ZAYO'S PRINEVILLE TO RENO PROJECT

CPUC MINOR PROJECT REFINEMENT FORM

RFI 489

AM_JumperRidgeRdToMilford_REV4	
AM - JUMPER RIDGE RD TO MILFORD	
SCALE: 1"=100'	SHEET NO.: 66 OF 84
JOB NUMBER: UPR	DATE: 12/13/24
DRAWN BY: WP	TITLE: 100% REV

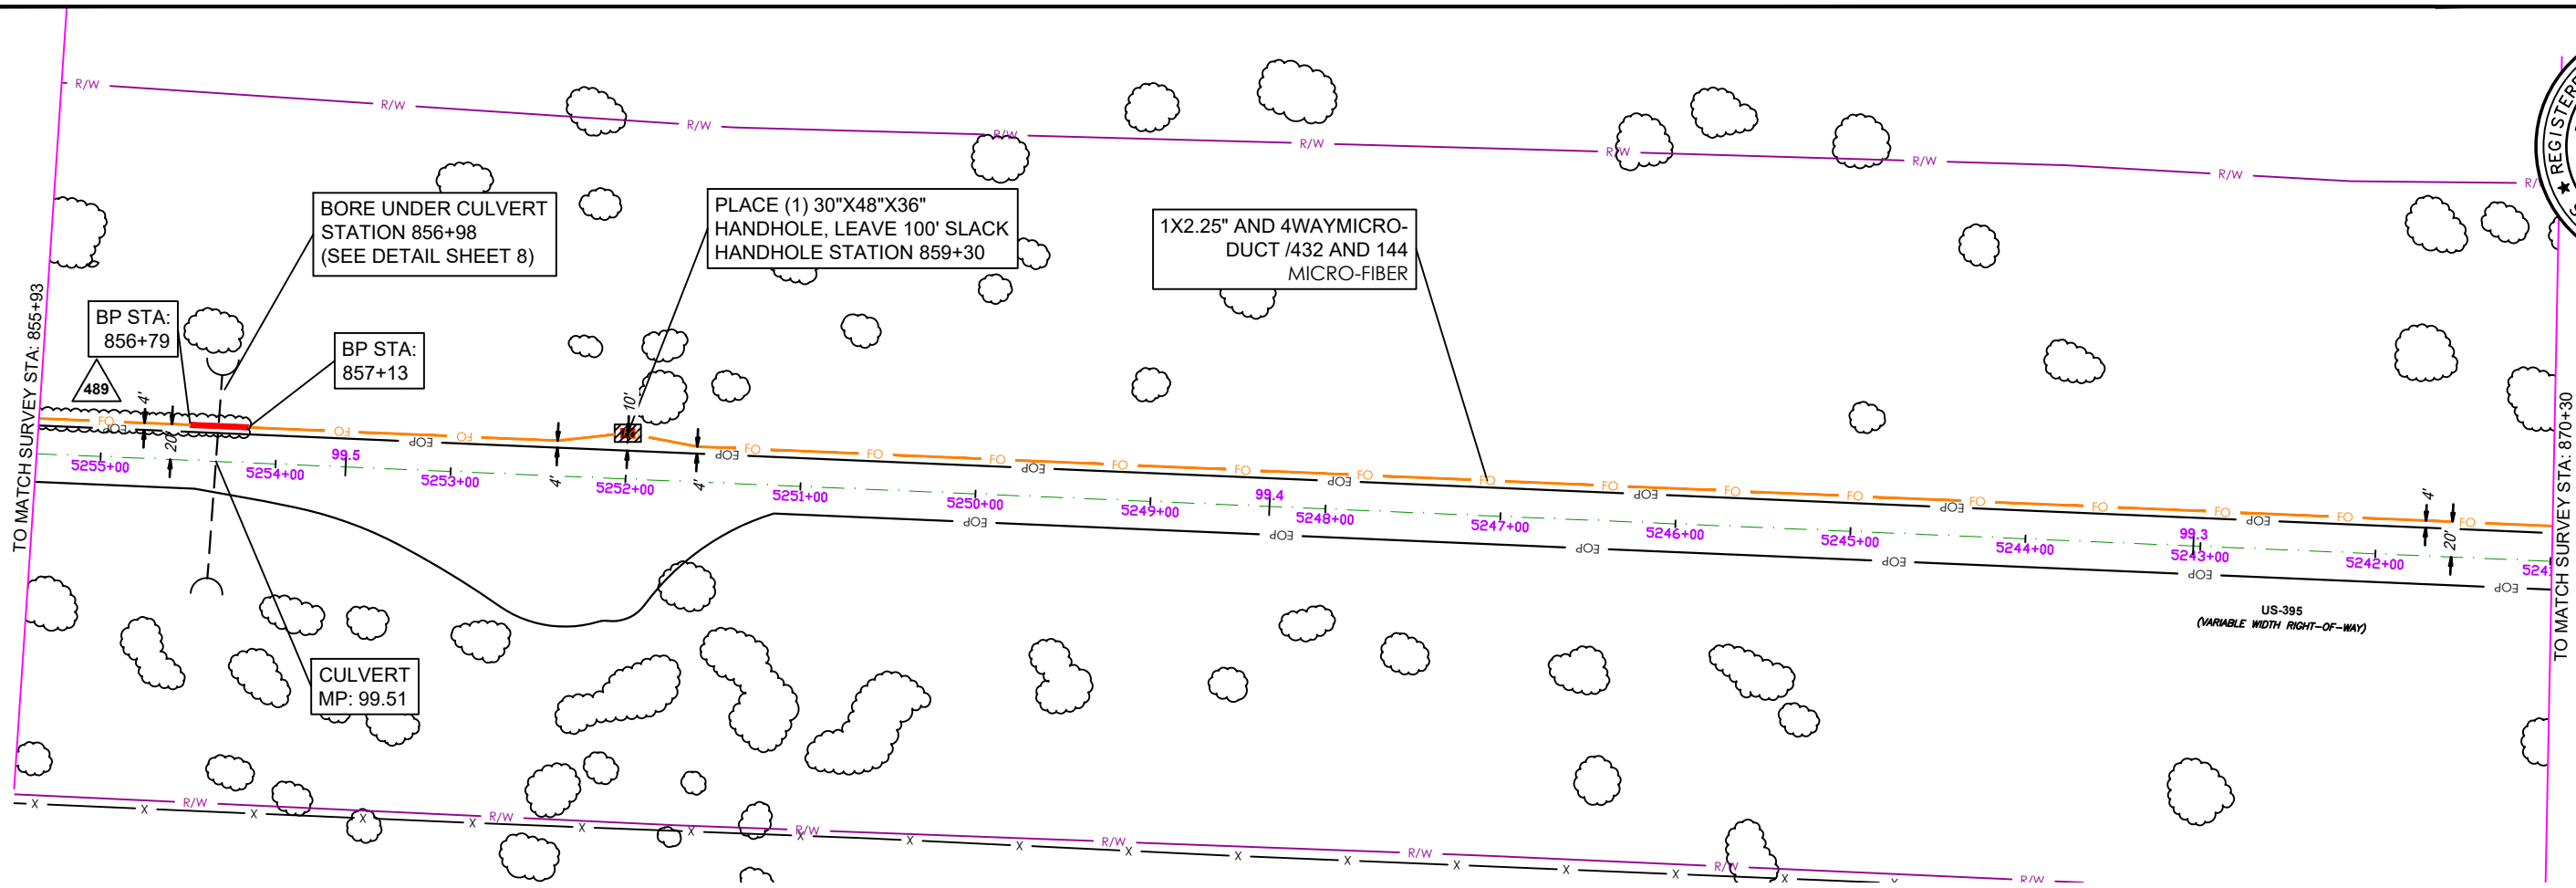
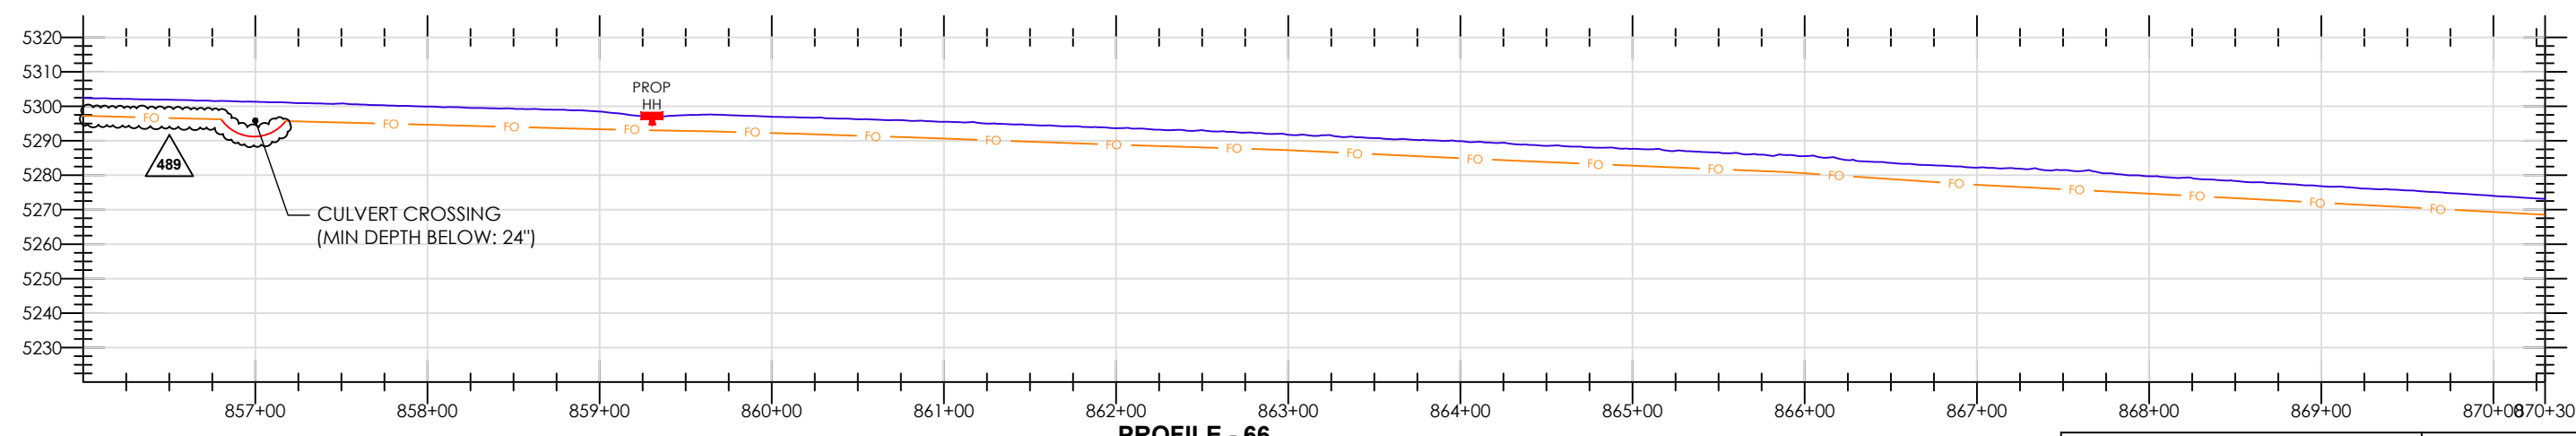
NOTES:	RFI NO. 0489 DEVIATE R/L TO 10' - 4" FROM EOP TO AVOID TREE LINES AND ROCK STA 821+50 TO 856+34	12/16/2024
FOR TRAFFIC CONTROL REFER TO 2023 CALTRANS STANDARDS AND LATEST EDITION OF CAMUTCD		
CAUTION RIGHTS-OF-WAY ARE DEPICTED BASED ON LATEST DOT RECORDS AVAILABLE. IF FURTHER ACCURACY IS REQUIRED, LAND SURVEYS WILL BE NECESSARY
